INDIANA DEPARTMENT OF TRANSPORTATION

APPROVED MINUTES

December 18, 2024, Standards Committee Meeting

E 707-BPBF-02 FABRICATION TOLERANCES PRESTRESSED BOX BEAM (proposed draft)

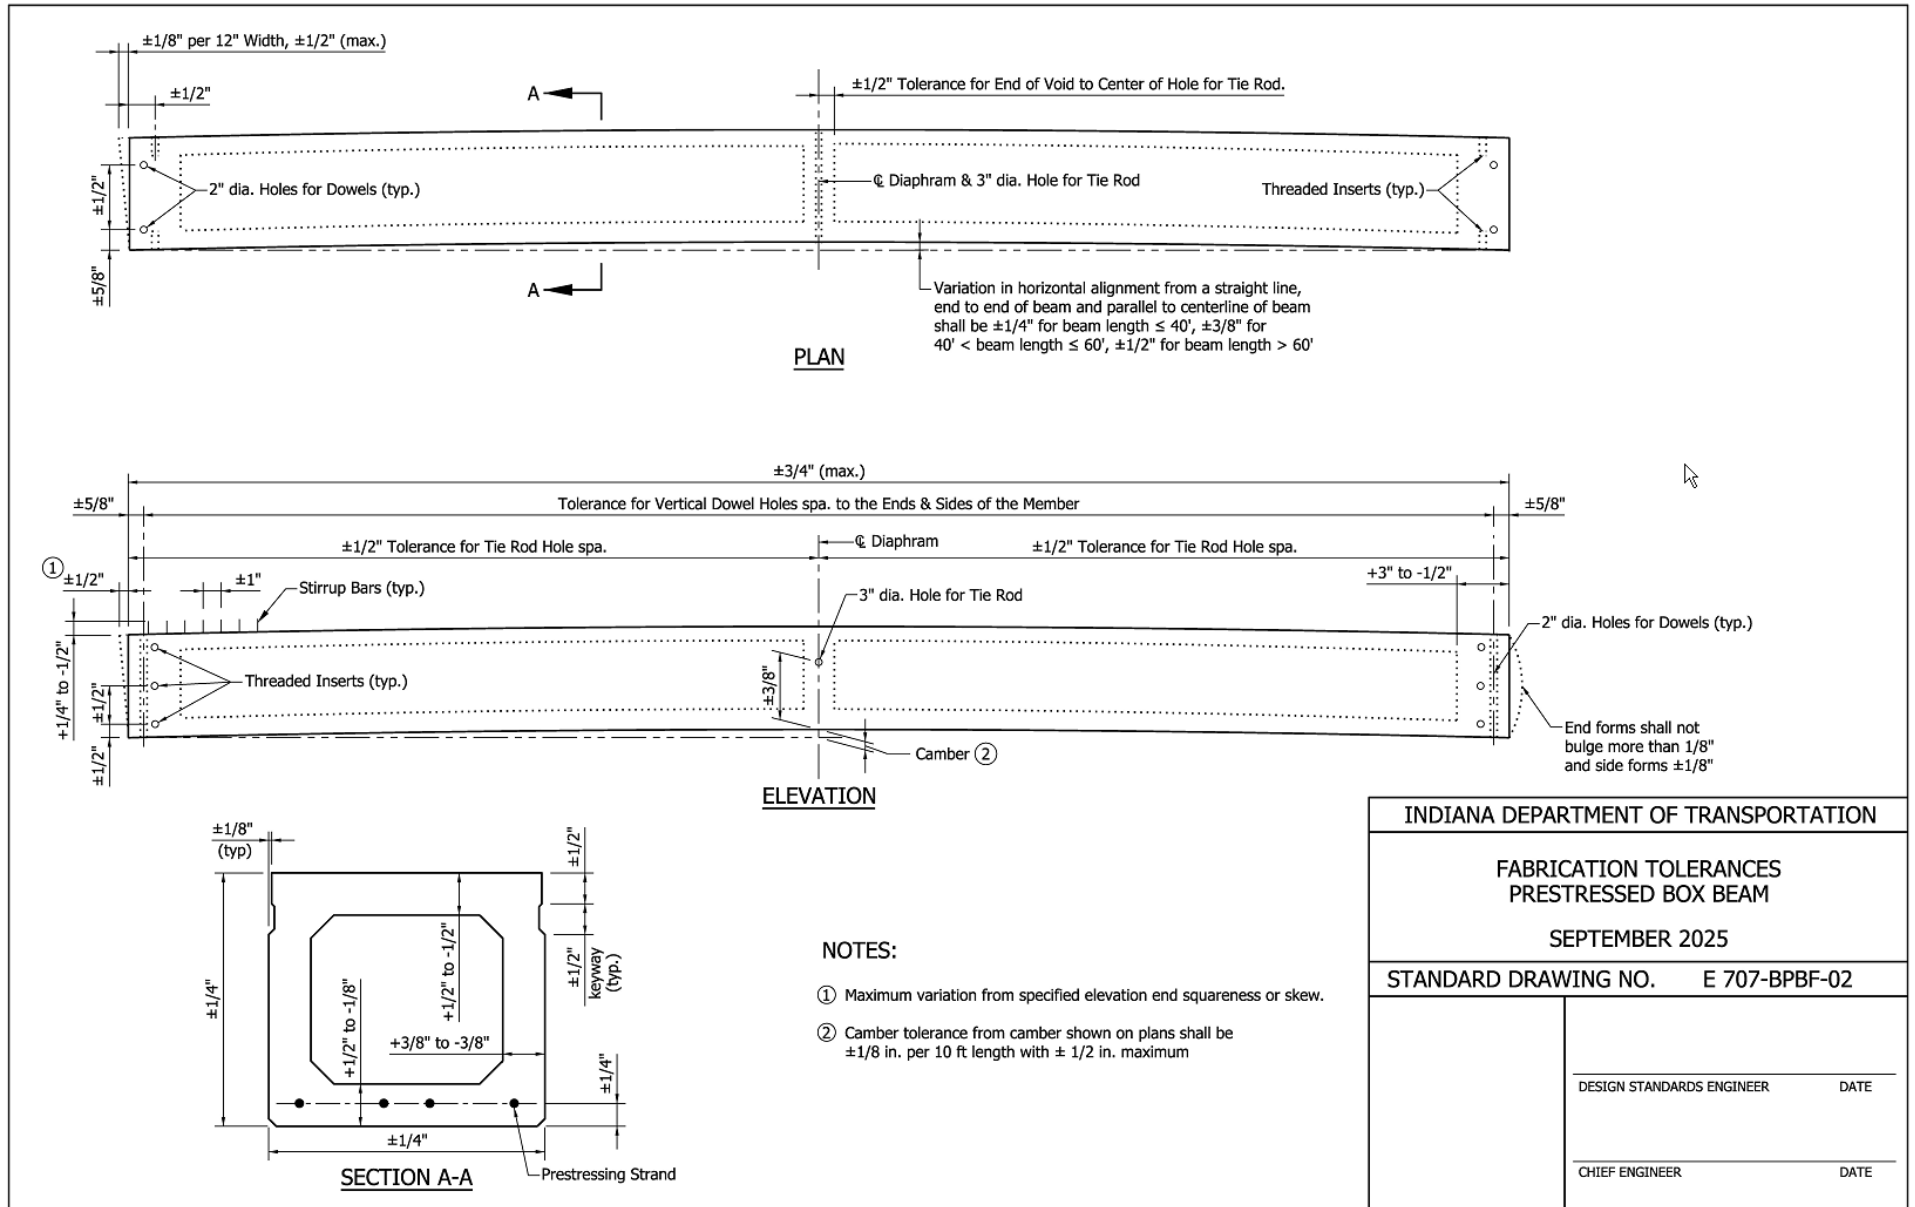
Symbols removed from
general notes sheet.

Local smoothness requirement
moved from individual sheets
to this sheet.
